Intersection ID: N/A	Main Street: SPRATT_ST	Cross Street: N/A	Location:	SW
ADA ID: DBFB49B155D0	Ramp Type: Perp	Initial Pass/Fail: Fail	Overall Compliance: No	Severity Score: 13.75

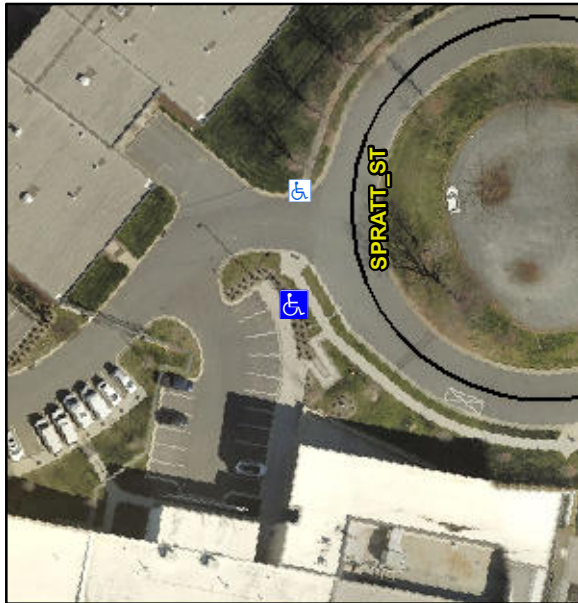
Not Found, R304.2.2

Possible Solutions:			Compliance	Description	Data	Compliance	Description	Data
Remove & Replace Entire Ramp.			N/A	Ramp Length (in)	74.0	No	Ramp Slope (%)	9.4
			Yes	Ramp Width (in)	48.0	Yes	Ramp XSlope (%)	3.3
			N/A	Flare Type LT	N/A	N/A	Flare Type RT	N/A
			N/A	Flare Slope LT (%)	N/A	N/A	Flare Slope RT (%)	N/A
			N/A	Flare Traversable LT?	N/A	N/A	Flare Traversable RT?	N/A
			N/A	Landing Length (in)	N/A	N/A	DWS Provided?	N/A
			N/A	Landing Width (in)	N/A	N/A	DWS Contrast?	N/A
			N/A	Landing Slope (%)	N/A	N/A	DWS Length (in)	N/A
			N/A	Landing X Slope (%)	N/A	N/A	DWS Full Width?	N/A
			N/A	Landing Curb? (Y/N)	N/A	N/A	DWS Offset (in)	N/A
Surveyor Notes: N/A			N/A	Shared Landing?	N/A			
			N/A	Gutter Ponding?	N/A	N/A	Gutter Slope (%)	N/A
			N/A	Gutter Lip Ht (in)	N/A	N/A	Gutter X Slope (%)	N/A
			N/A	Painted X Walk1?	No	N/A	Painted X Walk2?	N/A
				X Walk 1 Direction	To N		X Walk 2 Direction	N/A
			N/A	X Walk 1 Width (in)	N/A	N/A	X Walk 2 Width (in)	N/A

Remove & Replace Entire Ramp.
